Project	IEEE 802.16 Broadband Wireless Access Working Group < http://ieee802.org/16 >
Title	Multi-carrier Support in Relay
Date Submitted	2009-02-27
Source(s)	Jerry Sydir, Kamran Etemad Intel Corporation jerry.sydir@intel.com *< http://standards.ieee.org/faqs/affiliationFAQ.html >
Re:	SDD Change Request
Abstract	This contribution specifies multi-carrier support in the RS.
Purpose	For consideration and adoption into the 16m SDD document.
Notice	<i>This document does not represent the agreed views of the IEEE 802.16 Working Group or any of its subgroups.</i> It represents only the views of the participants listed in the "Source(s)" field above. It is offered as a basis for discussion. It is not binding on the contributor(s), who reserve(s) the right to add, amend or withdraw material contained herein.
Release	The contributor grants a free, irrevocable license to the IEEE to incorporate material contained in this contribution, and any modifications thereof, in the creation of an IEEE Standards publication; to copyright in the IEEE's name any IEEE Standards publication even though it may include portions of this contribution; and at the IEEE's sole discretion to permit others to reprod

Figure 1 Multi-carrier operation across multi-carrier ARS

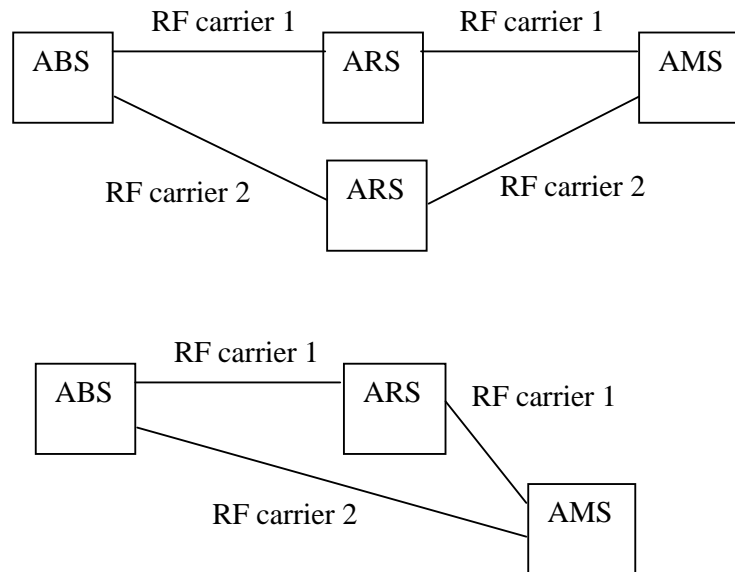
We believe that ARSs should be used only to relay fully configured carriers as partially configured carriers are mainly targeted for high power broadcast only carriers which in most cases are synchronized to provide macro-diversity. When ARSs are deployed in a multi-carrier deployment individual ARSs can support multiple RF carriers or only a single RF carrier. An example of multi-carrier operation using a multi-carrier RS is shown in Figure 1. A more interesting and useful usage of ARS is when single carrier ARS’s are used to provide multi-carrier connections., Examples of this usage are conceptually shown in Figure 2. It should be noted that in Figure 2 RF carrier 1 and RF carrier 2 are assumed to be different RF carriers with different center frequencies and that multi-carrier operation across single-carrier ARSs does not involve cooperative relay transmissions or the use of virtual MIMO techniques.

When ARSs operate in a multi-carrier deployment, data is transmitted on a given carrier for the entire path between the ABS and AMS. For example, an MPDU transmitted from the ABS to the ARS on RF carrier 1 is transmitted to the AMS on RF carrier 1.

When ARSs are deployed in a deployment where the multi-carrier feature is used individual ARSs can support multiple RF carriers or only a single RF carrier. ARSs are used only to relay fully configured carriers.

When ARSs operate in a multi-carrier system, data is transmitted on a given carrier for the entire path between the ABS and AMS. For example, an MPDU transmitted from the ABS to the ARS on RF carrier 1 is transmitted to the AMS on the same RF carrier 1.
